SITE PLAN MODIFICATION
505 WEST CENTRAL STREET
LOT 3
(515 WEST CENTRAL STREET)
FRANKLIN
MASSACHUSETTS

FIELD CHANGE
PLAN

RE: Request for Field Change
515 West Central Street, Franklin, MA

Date: December 13, 2023 Job No.: 10520.07
To: Ms. Breeka Lí Goodlander
Mr. Gregory Rondeau
Cc: Amy Love, Mike Maglio
From: Matt Crowley
Subject: **515 West Central Field Changes**

PROPOSED FIELD CHANGES

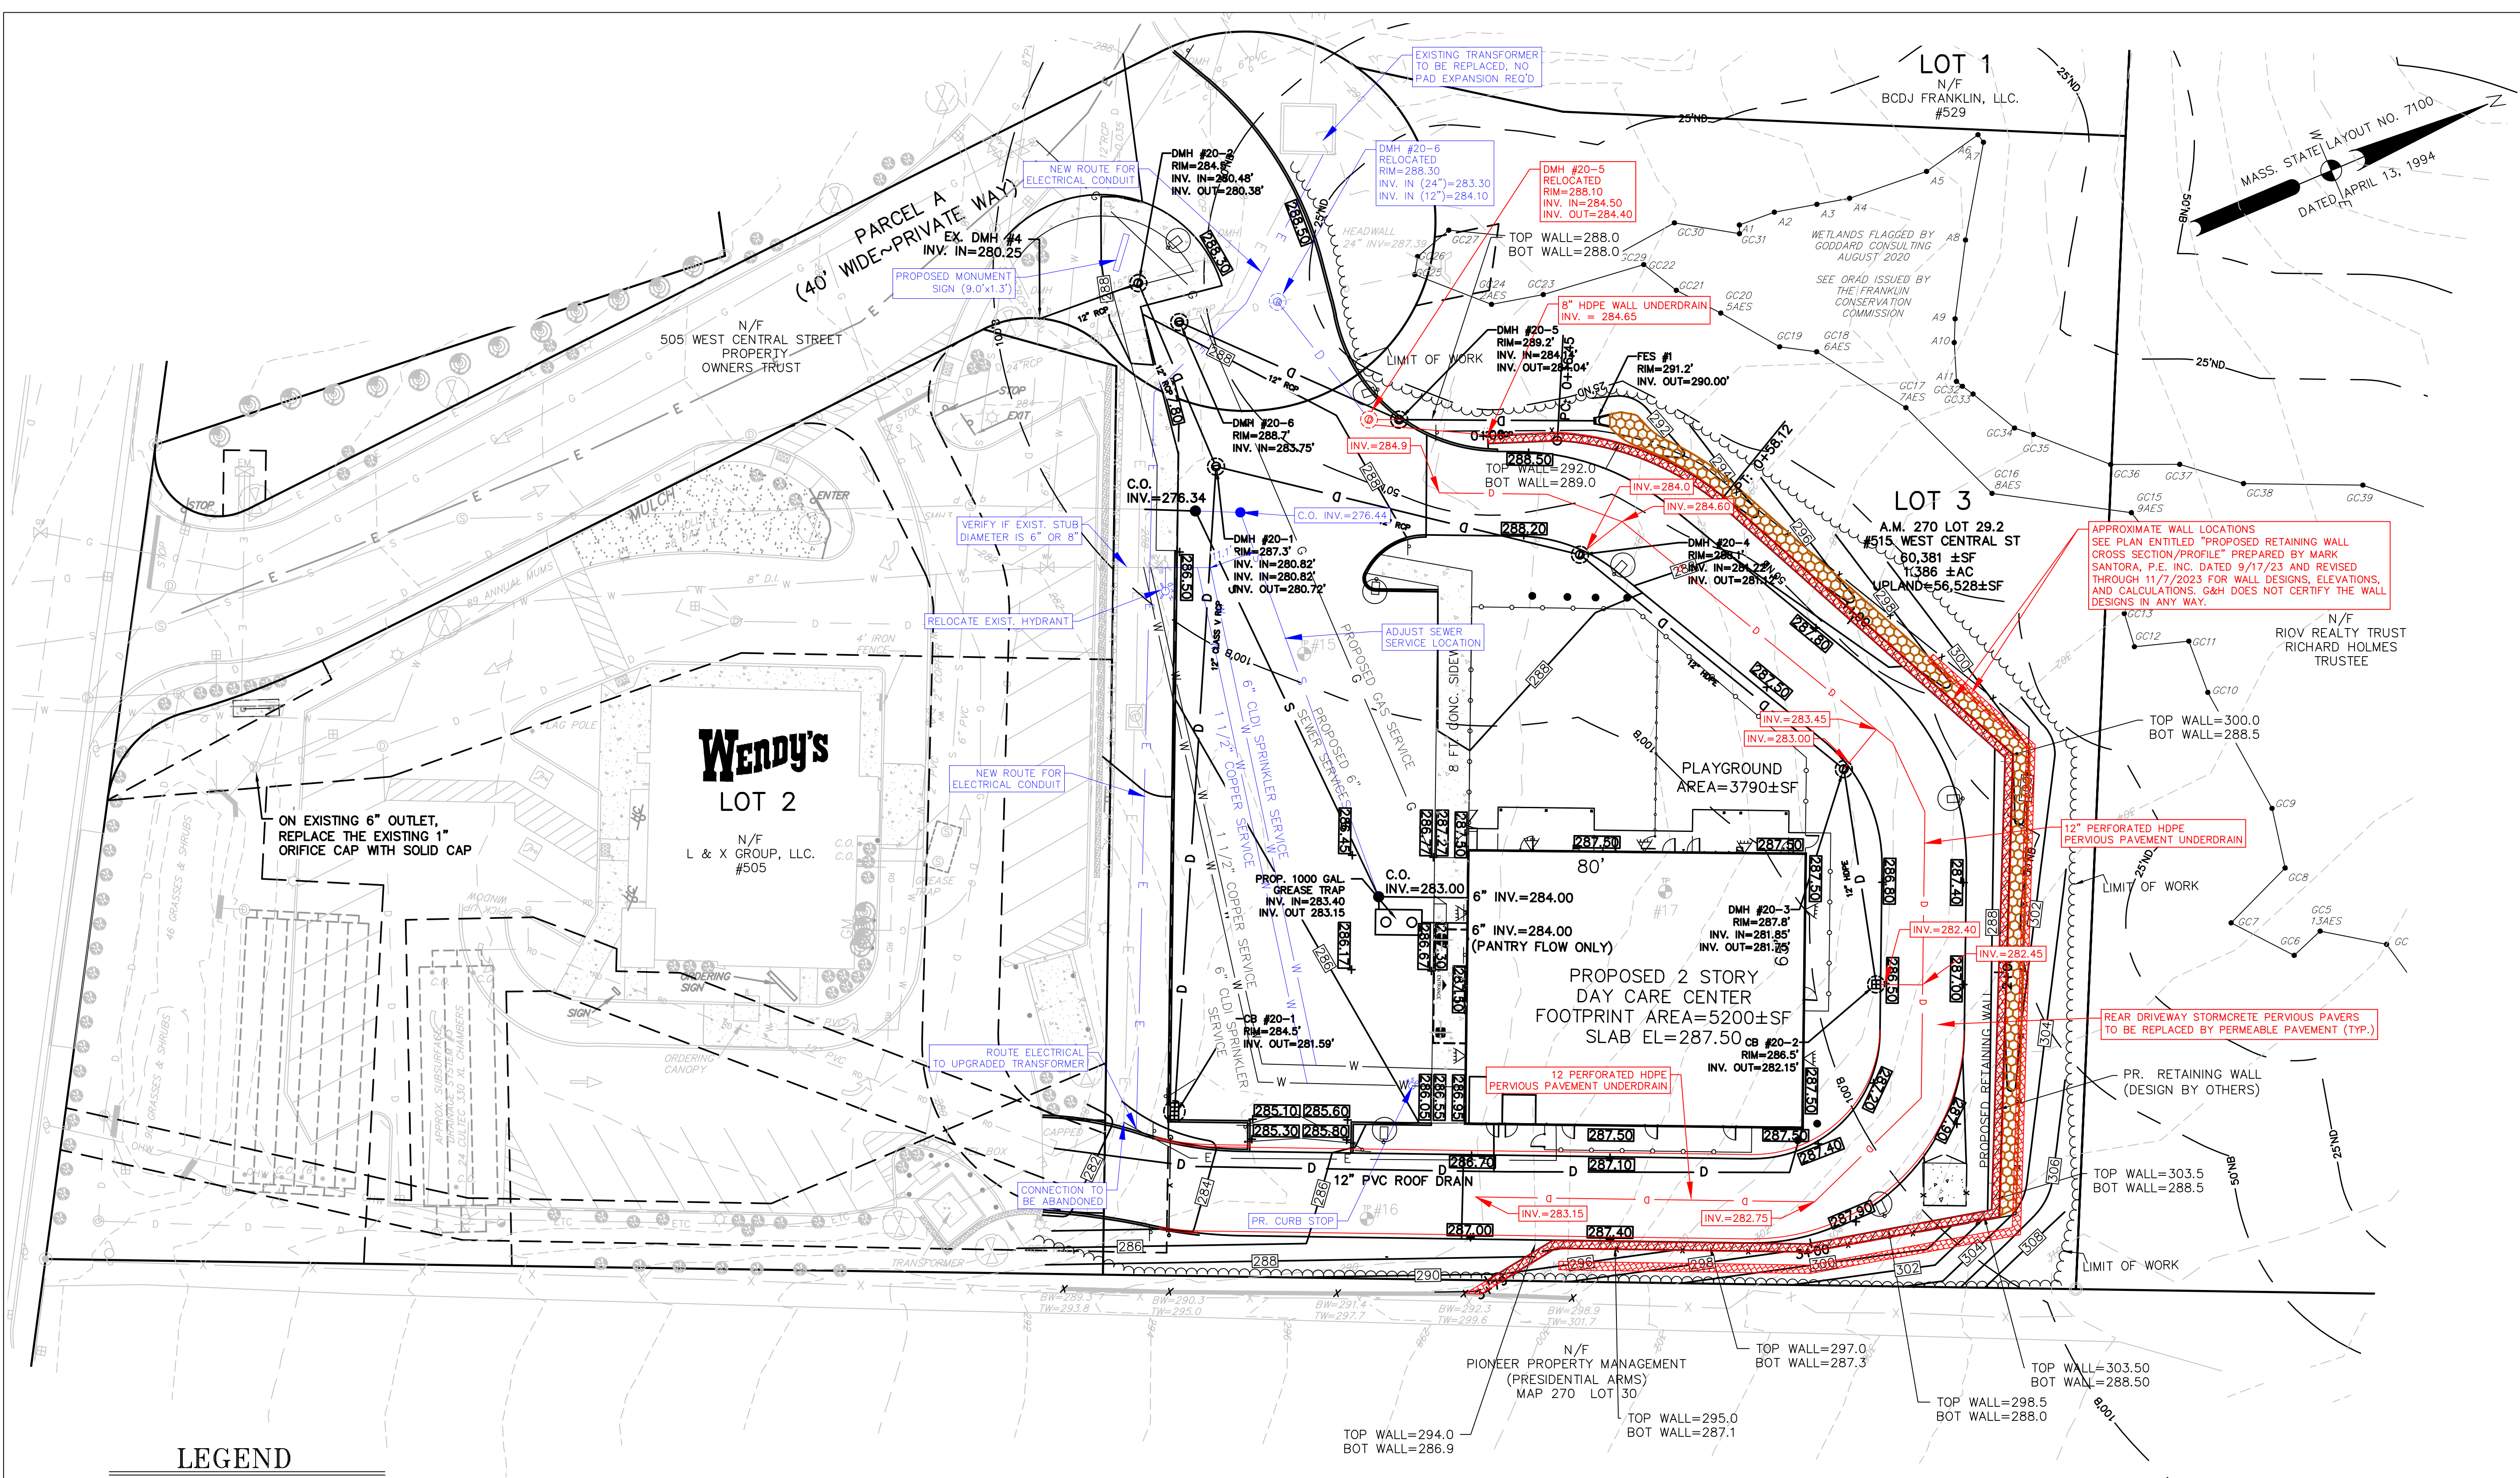
- STORMCRETE PERVIOUS PAVERS TO BE REPLACED BY PERMEABLE PAVEMENT. DUE TO LEDGE AND PERSISTENT HIGH GROUNDWATER BENEATH THE REAR ACCESS ROAD, INSTALLATION OF AN UNDERDRAIN CONNECTED TO THE STORMWATER CHAMBERS IS PROPOSED.

- THE PROPOSED WALL DESIGN IS TO BE A TERRACED DESIGN PREPARED BY MARK SANTORA, P.E. INC. INSTALLATION OF A SUBDRAIN 4" BELOW THE PROPOSED RETAINING WALL IS PROPOSED TO INTERCEPT GROUNDWATER ENTERING THE SITE, AND WILL CONNECT TO DMH #20-5.

- DMH#20-5 AND DMH #20-6 LOCATIONS ADJUSTED TO AVOID CONFLICTS WITH EXISTING AND PROPOSED UTILITIES.
- EXISTING TRANSFORMER AT SITE ENTRANCE TO BE UPGRADED, AND NEW ELECTRICAL SERVICE CONDUIT INSTALLED PARALLEL TO THE EXISTING RUN.

- FIRE AND DOMESTIC SERVICE CONNECTIONS TO BE MODIFIED TO ACCOUNT FOR FIELD CONDITIONS. CONTRACTOR TO VERIFY DIAMETER OF EXISTING STUB. EXISTING HYDRANT TO BE RELOCATED. SEWER SERVICE TO BE ADJUSTED TO MAINTAIN MIN 10" SEPERATION TO WATER SERVICES.

- MONUMENT SIGN PROPOSED AT SITE ENTRANCE.

PERVIOUS PAVEMENT CROSS SECTION
N.T.S.

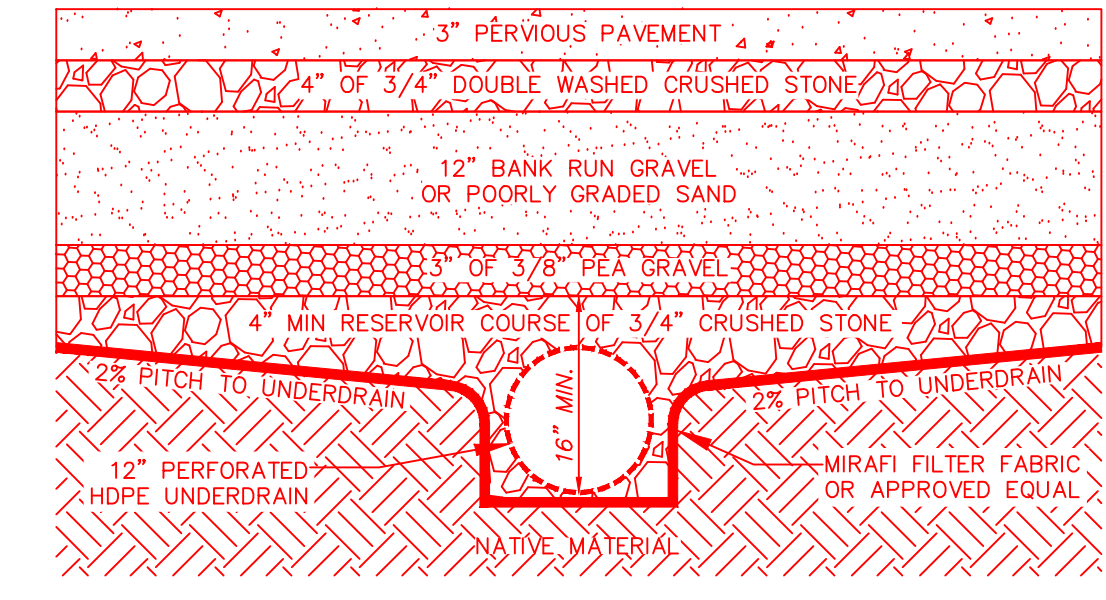
- The proposed pervious pavement detail is generally consistent with the Stormwater Handbook. Comments specific to the porous pavement are as follows:
 - The designer should confirm the proposed porous pavement thickness of 3" is suitable to support waste collection vehicle and fire apparatus loads. Porous pavement has a lower load-bearing capacity than conventional pavement.

- The bottom of the reservoir course should be flat, and it is recommended to raise the subdrain from the reservoir bottom to promote recharge when groundwater levels stabilize or are lower during the dry season.

RETAINING WALL PROFILE - TYPICAL

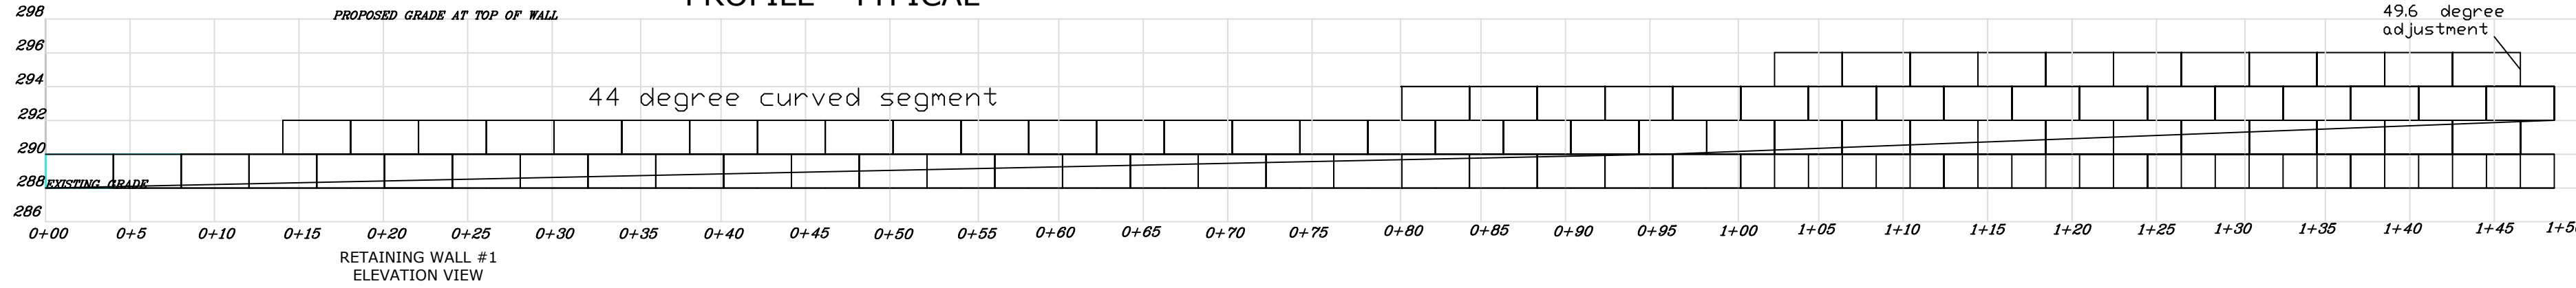
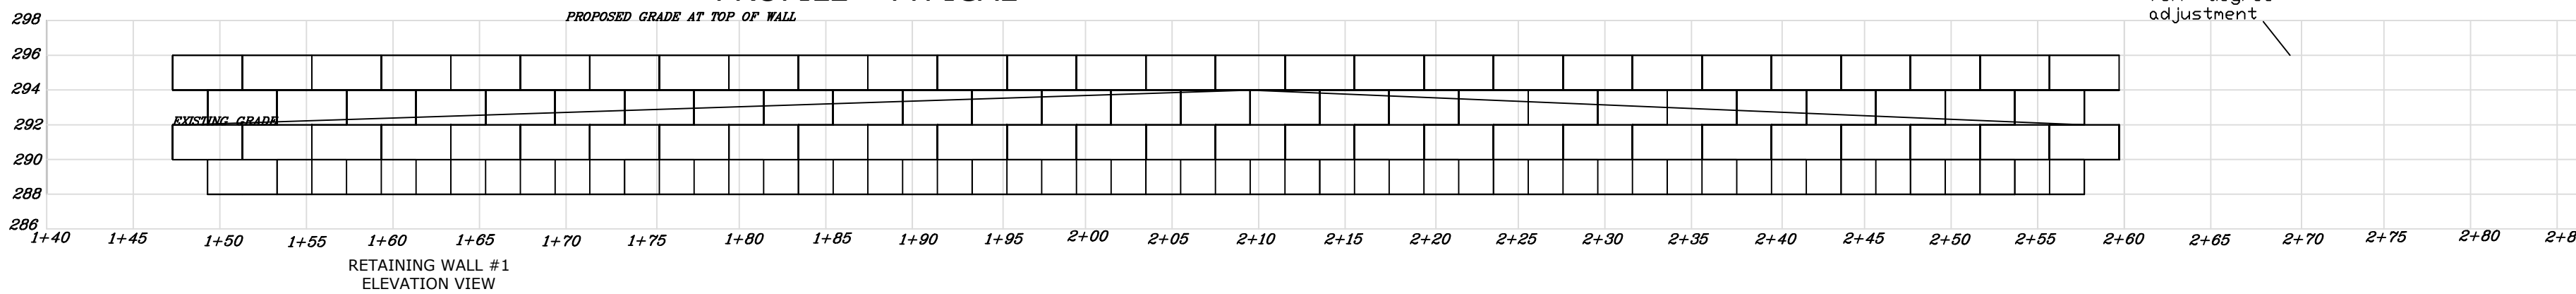
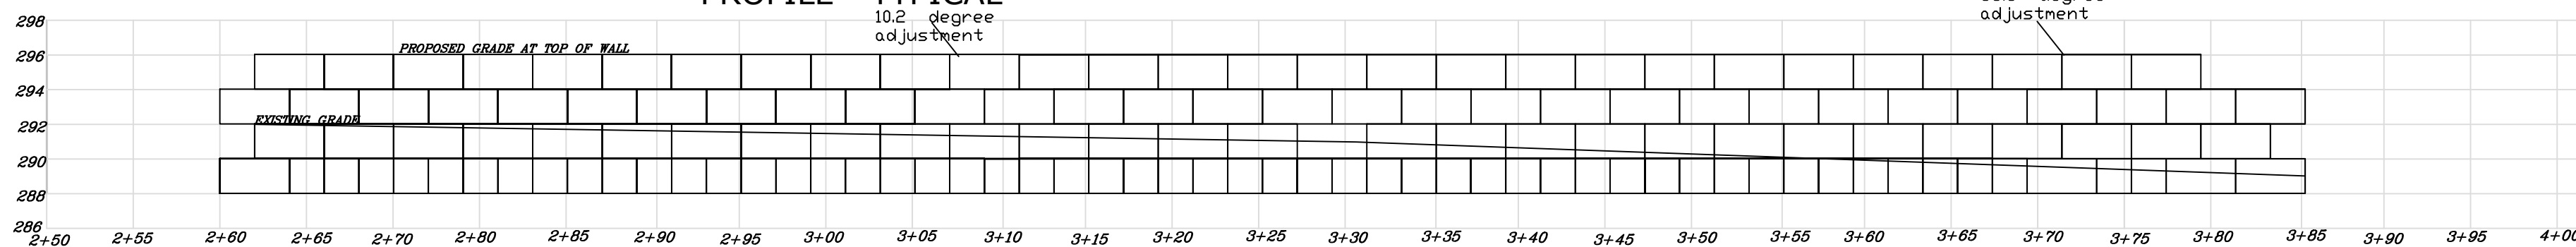
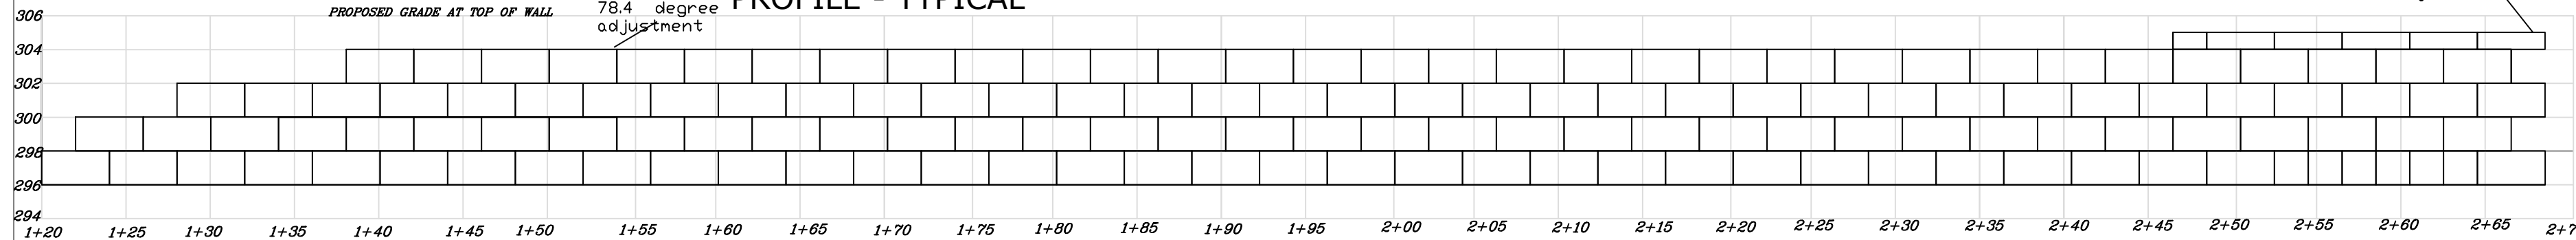
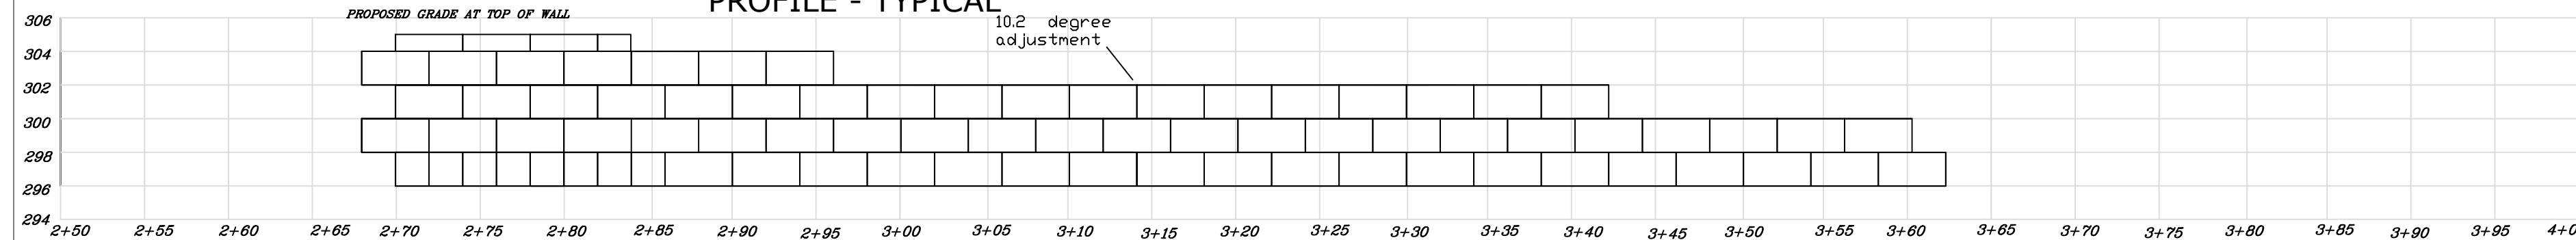
These tiered walls are close enough that the lower wall needs to be designed for surcharge loading. To avoid surcharge loading, the upper wall needs a setback of twice the height of the lower wall.

The overturning calculation doesn't appear to take into consideration the varying block depths.

Acknowledged – At a site meeting in October with the Design Engineer of Record, Owner, Site Contractor & Large block manufacturer, it was observed that the material behind the proposed walls is predominantly stable bedrock. The wall designs have been modified to show the proposed upper tier to be installed on a shelf of stable bedrock. The site contractor has indicated that he would be able to shape the rock to accommodate the new design concept. As a result the upper walls weight will not surcharge to the lower wall.

Acknowledged – The overturning calculation does not consider the varying block depths however the calculation is conservative in that the lower block turned sideways provides additional stability due to the weight of the backfill soil on the section of the lower block that protrudes to the rear. The calculation assumes only the weight of the blocks as a resisting moment when in fact the soil on top of the lower block adds to the resisting force.

Additionally, pursuant to a suggestion made by the design engineer, we have added a 6' wide footing at the base of the lower wall that will extend the base another 2 feet. The extended base will double the weight of soil backfill increasing the resisting moment further. We also have added proposed geogrid tying the top of the lower wall to the bottom of the upper wall.

As a result the factor of safety against overturning is significantly higher than the calculated factor of safety of 10.6.
